Central Barangaroo MOD 9

Supplementary
Response to Submissions

Prepared for
Aqualand
June 2024

Figure 2 – Indicative Massing under existing Concept Plan approval

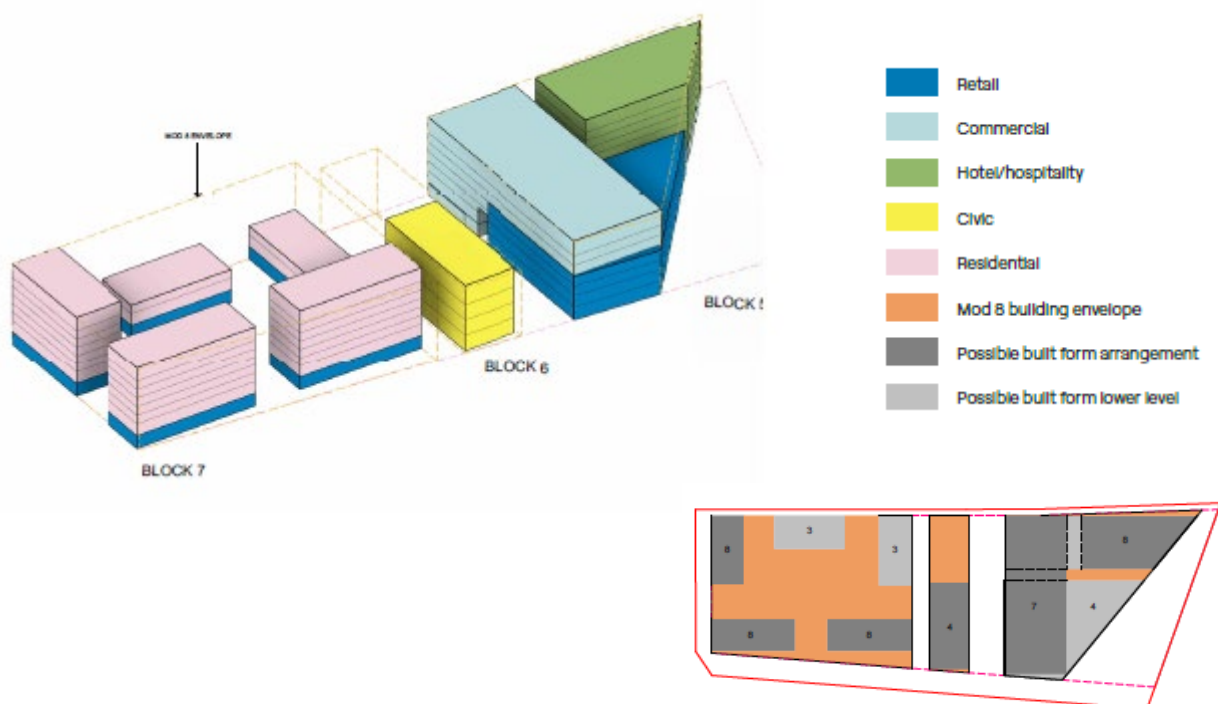
*1. To enable a full assessment of the proposed increase in gross floor area (GFA) and address Item 1 of the Department's previous issues letter, you are requested to **provide indicative massing plans representing the approved GFA**. These plans should also consider:*

- *The envelopes/massing shown in previous representations (e.g., the **original concept plan, MODs, 2, 3 and 4**)*
- *The block layout changes from previous MODs (MODs 3 and 8)*
- *The **current concept plan controls** (including the envelope amendments for Block 5 and the Design Principles, Design Requirements, and Development Controls).*

*All relevant reports, including the Visual and View Impact Assessment (**VVIA**), Heritage Impact Statement (**HIS**), and **overshadowing analysis** must be updated accordingly. Additionally, the updated VVIA should include a **view-sharing analysis** that is consistent with the NSWLEC Planning Principle (including the steps in *Tenacity Consulting v Warringah [2004] NSWLEC 140*) and the updated overshadowing analysis should clearly show the approved vs proposed impacts of the proposal.*

To provide DPHI with additional information to help facilitate its assessment, and in the absence of any illustrative scheme being available, the Applicant has prepared indicative massing within the approved Concept Plan block envelopes that reflects the approved GFA (**Figure 1**).

This indicative massing is consistent with the established concept plan principles and key planning documents (e.g. the Apartment Design Guide – **ADG**). The indicative massing including a list of assumptions is provided at **Appendix 1**.

As approval is not sought for this indicative massing, it is provided only in response to DPHI's request. We re-affirm the appropriate comparative analysis for assessment purposes is a comparison of the approved and proposed Concept Plan envelopes.

Figure 5 – Amended envelope and block layout

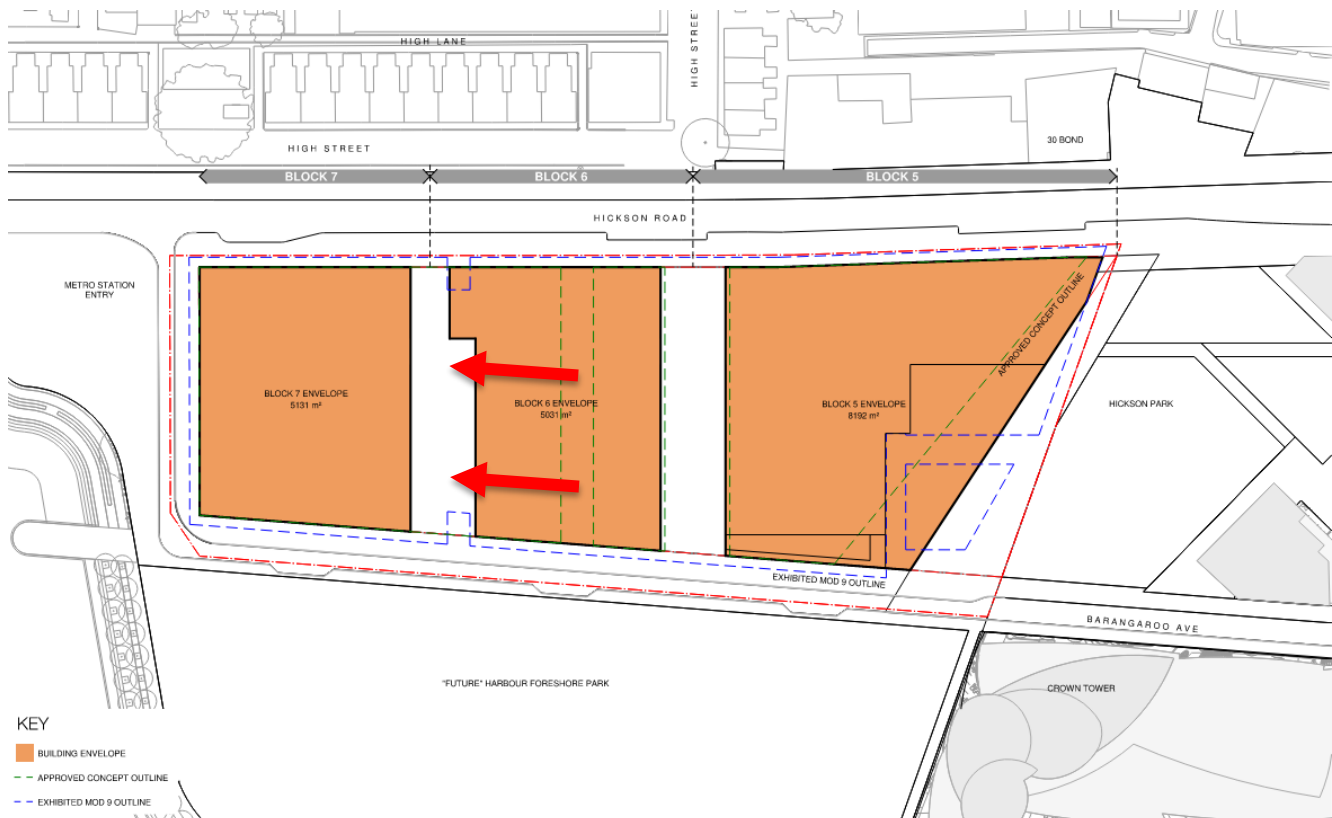
Applicant's Response

While the eastern end of this link is 12 metres wide, it exceeds the 10 metre width referred to the current approval and opens out to 20 metres for most of its length at Harbour Park end. The current configuration as exhibited at RtS stage is therefore not proposed to change. Refer to **Figure 5**.

It is noted that Exchange Place within Barangaroo South is a 12 metre wide east west link that connects directly to Wynyard Walk and has some of the highest pedestrian usage within the Barangaroo site. During the assessment process the Department raised concern with the reduction in width of that east west link but ultimately supported 12 metres.

Figure 6 – Barangaroo Avenue section

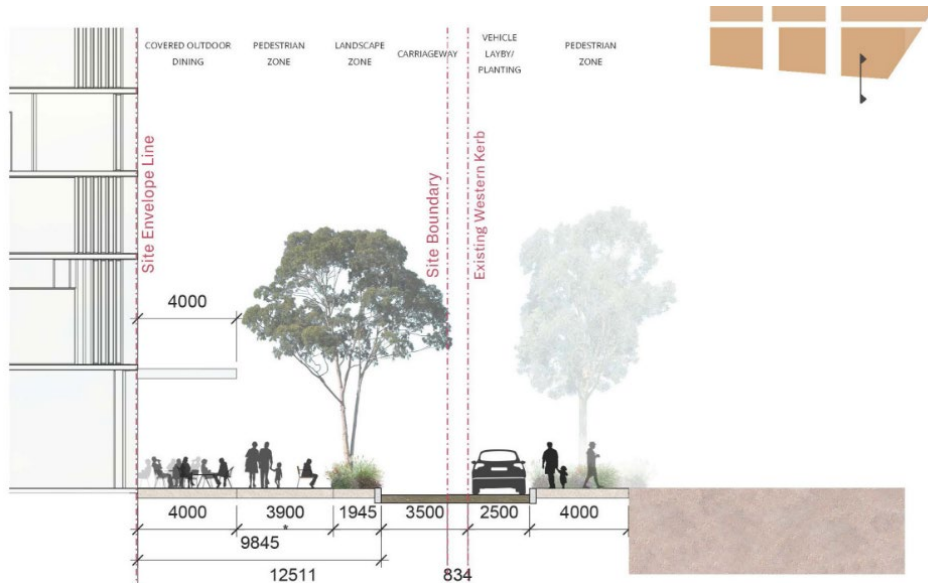
Sheltered Access

While **Figure 6** (from **Appendix 2**) indicates dining under the awning, with pedestrian movement beyond. This is consistent with Barangaroo South where awnings are provided in certain locations, and pedestrian movement is provided beyond that. It is further noted that Crown Casino provides limited sheltered access.

Figure 8 – Historic footbridge (above) and indicative footbridge (below)

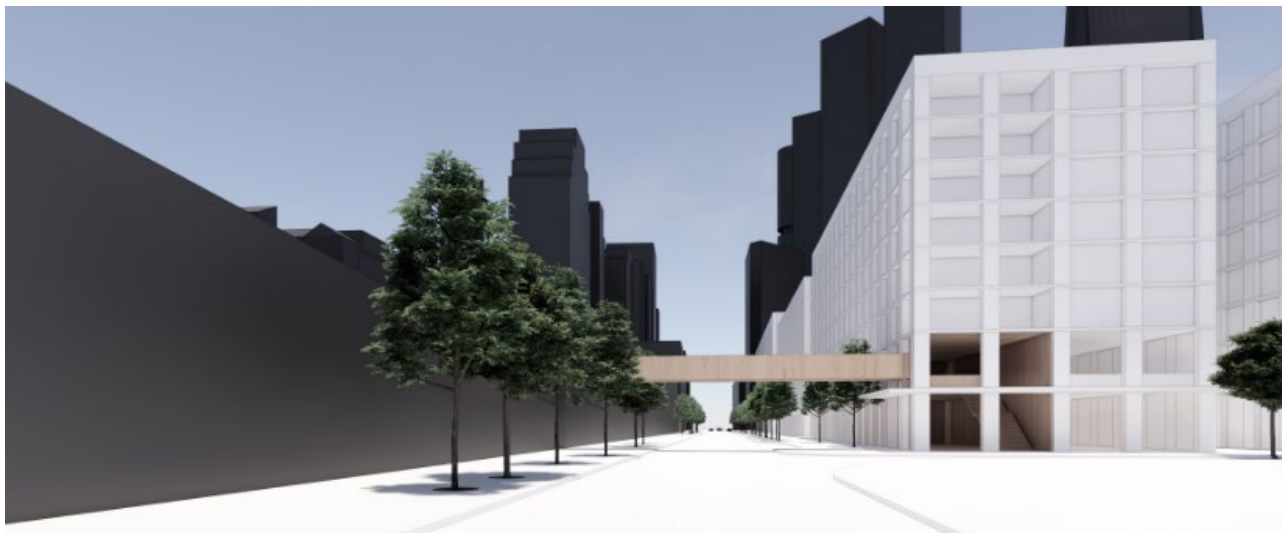
Applicant's Response

The RtS reference scheme indicates the intended integration of the bridge into Block 7. We note this is consistent with the original bridge structure which connected directly from High Street into the upper levels of the wharf building – see **Figure 8** below.

The bridge will be highly visible and accessible from Nawi Cove and Millers Point. It will be clearly signed from within the public domain as part of the precinct wayfinding, ensuring ease of pedestrian movement to and from Nawi Cove and the Barangaroo Metro station. Integrating the bridge with Block 7 ensures direct and integrated access to the Barangaroo Metro Station immediately below, providing direct and efficient access to residents from Millers Point to the station.

Additional analysis in relation to this interface is provided at **Appendix 2, Page 24**. The final design of the bridge will be subject to future design excellence and detailed SSDA processes.

Figure 9 – Eye height view from Hickson Park

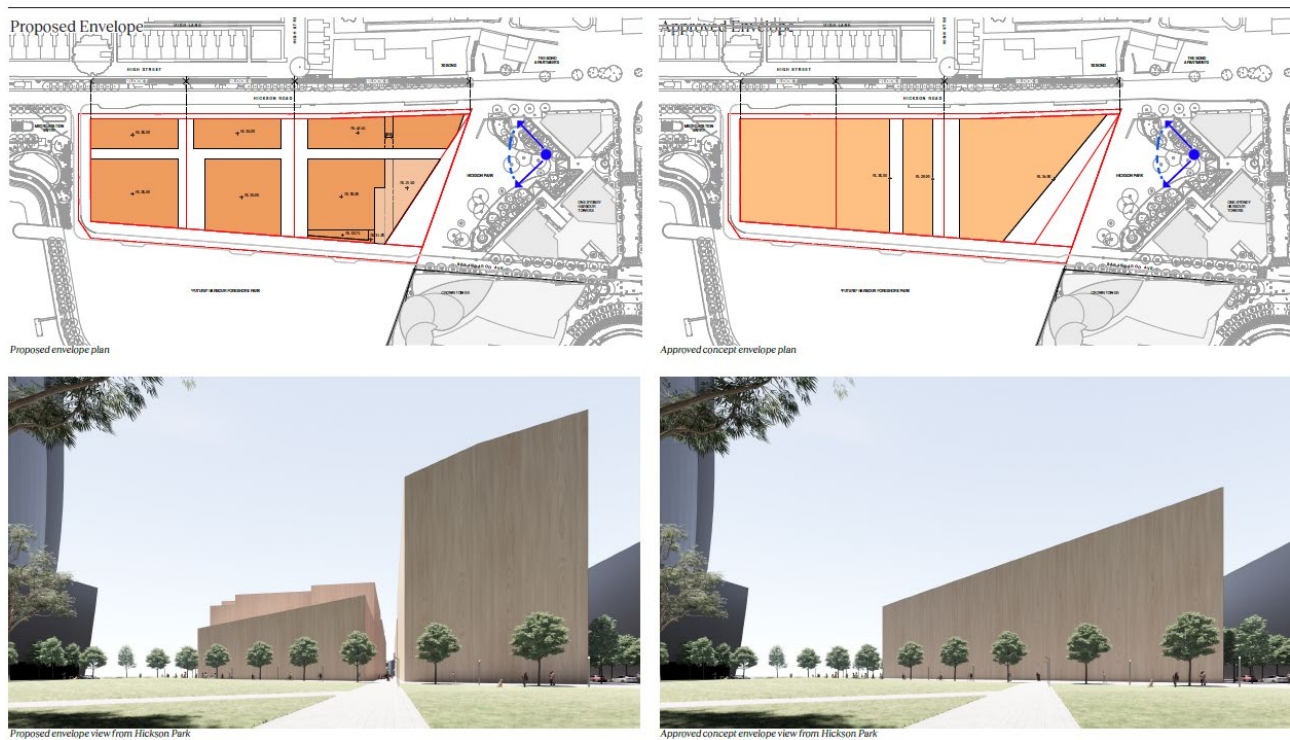
Eye height view analysis

An additional eye height view comparing the approved and proposed envelopes is provided at **Appendix 2, Page 27**.

Figure 11 – Deep soil plan depicting locations of deep soil and landscape zones over basement

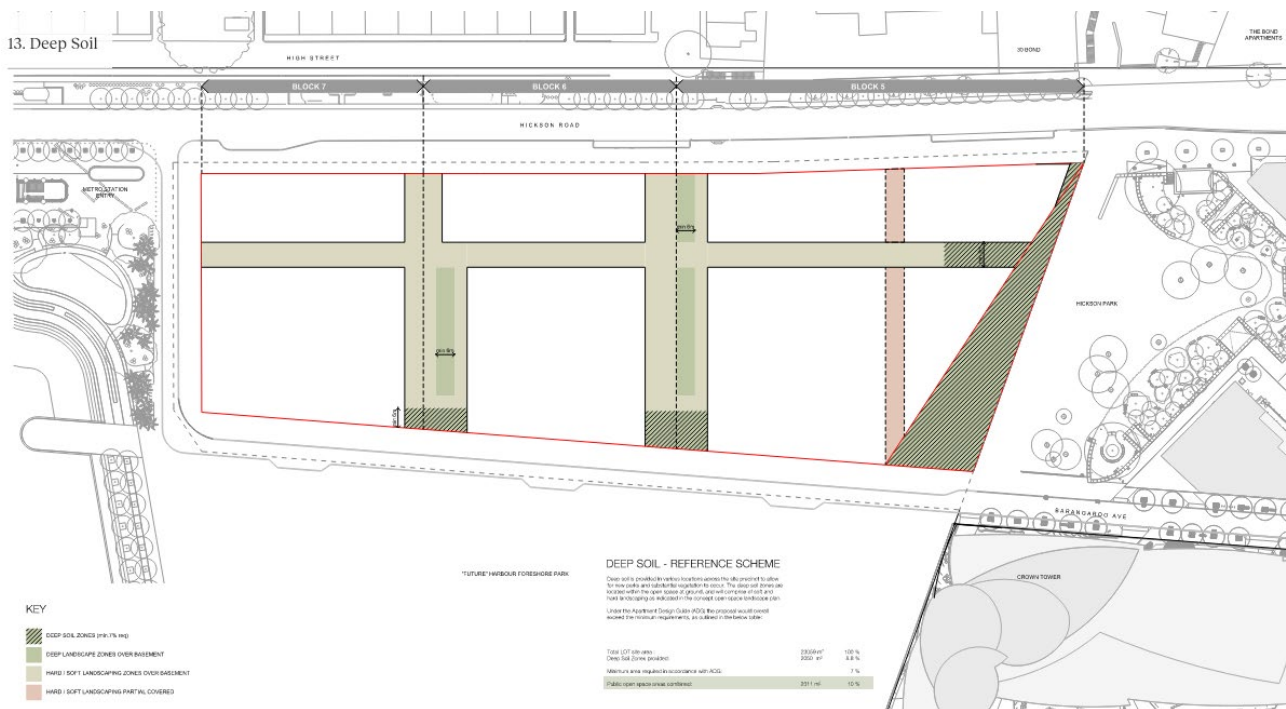
6. Confirm the extent of deep soil provision across the site on all plans and reports, noting that deep soil will have no impeding structure(s) below. Significant and connected soil depth above any basement must be provided to ensure the longevity of mature street tree planting.

A deep soil plan is provided at **Appendix 2, Page 15**, which demonstrates the extent of unimpeded deep soil when considered with the basement included in the RtS reference scheme. Refer to **Figure 12**. This indicates the potential for over 8% deep soil, which can be delivered along Hickson Park and adjacent to Harbour Park. In addition, the plans demonstrate opportunities for landscaping within the site's links and plazas. The precise location of deep soil and landscaping will be subject of future SSDAs.

The total provision of deep soil should be read in context across the entire Barangaroo Precinct. The wider precinct provides varying deep soil approaches to Headland Park, Harbour Park and Barangaroo South, all of which demonstrate capacity for mature planting and significant trees without the need for conventional deep soil (as defined by the ADG). Furthermore, over 50% of Barangaroo will be retained as public open space.
